Access Compliance Report

Public Rights-of-Way

(Curb Ramps)

Intersection ID: 10015016	Main Street: WILORA_LAKE_RD	Cross Street: N/A	Location: SW
ADA ID: F0E2E3B7DACF	Ramp Type: Perp	Initial Pass/Fail: Fail	Overall Compliance: No
			Severity Score: 12.5

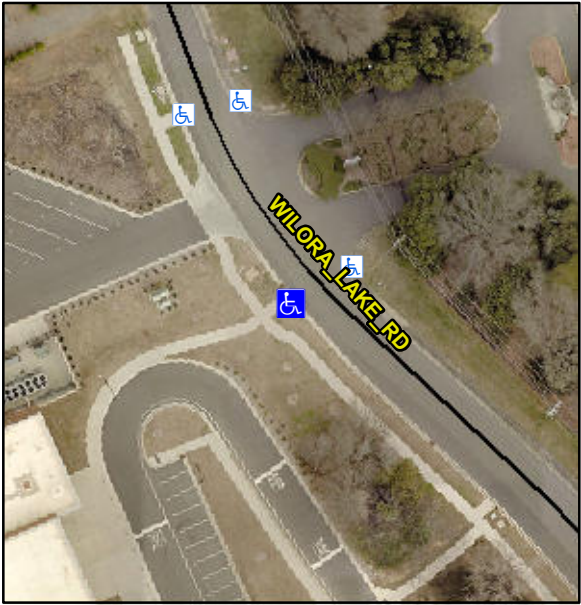
Codes/Mitigation Info/Possible Solution			Field Measurements/Component Compliance		
	Possible Solutions:		Compliance	Description	Data
	Remove & Replace Entire Ramp.		No	Ramp Length (in)	98.0
			Yes	Ramp Width (in)	59.0
			N/A	Flare Type LT	N/A
			N/A	Flare Slope LT (%)	N/A
			N/A	Flare Traversable LT?	N/A
			N/A	Landing Length (in)	N/A
			N/A	Landing Width (in)	N/A
			N/A	Landing Slope (%)	N/A
			N/A	Landing X Slope (%)	N/A
<p>Surveyor Notes:</p> <p>N/A</p> <p>PROW/ADA:</p> <p>Not Found, R304.2.2</p>			N/A	Flare Type RT	N/A
			N/A	Flare Slope RT (%)	N/A
			N/A	Flare Traversable RT?	N/A
			N/A	DWS Provided?	N/A
			N/A	DWS Contrast?	N/A
			N/A	DWS Length (in)	N/A
			N/A	DWS Full Width?	N/A
			N/A	DWS Offset (in)	N/A
			N/A	Shared Landing?	N/A
			N/A	Gutter Ponding?	N/A
			N/A	Gutter Lip Ht (in)	N/A
			N/A	Painted X Walk1?	No
				X Walk 1 Direction	To E
			N/A	X Walk 1 Width (in)	N/A
				X Walk 1 Slope (%)	1.8
				X Walk 1 X Slope (%)	0.1

N/A	Ramp inside XWalk1?	N/A
			N/A	Road Slope (%)	N/A
			N/A	Road X Slope (%)	N/A
			N/A	Any Obstructions?	N/A
Total Cost:		\$ 1850.00		Obstruction Type	
			N/A		
			Yes	Surface Condition? (G/P)	Good
